GTR-ESC-2007-04

Addendum

Global Technical Regulation No. 6 (?)

ELECTRONIC STABILITY CONTROL (ESC) SYSTEMS

Figure 1. Steering wheel position and yaw velocity information used to assess lateral stability.

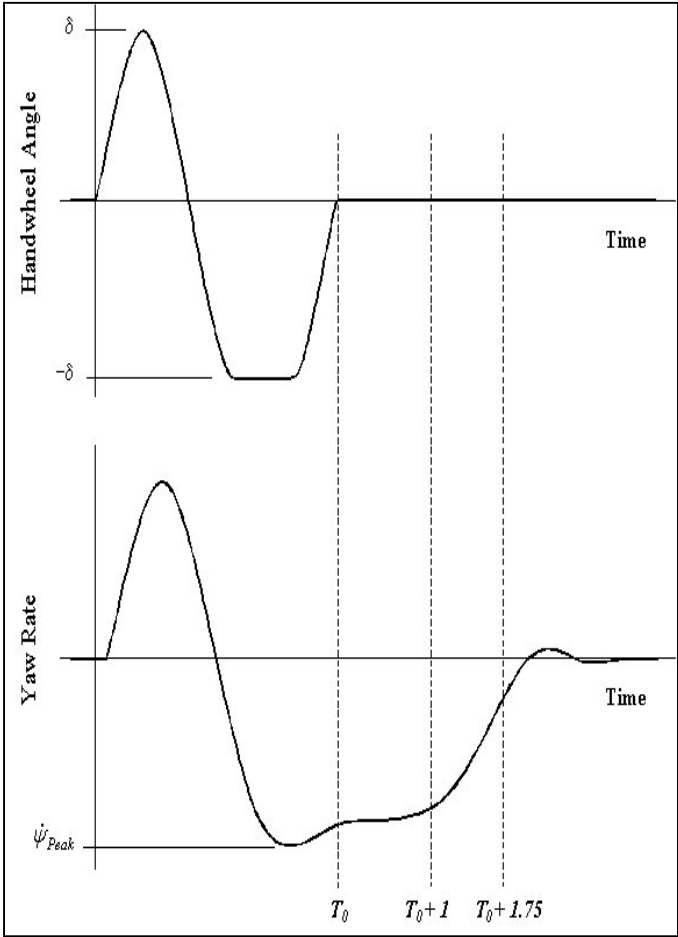
["Handwheel" to be corrected into "steering wheel"]
[Provide "passing" AND "failing" example]
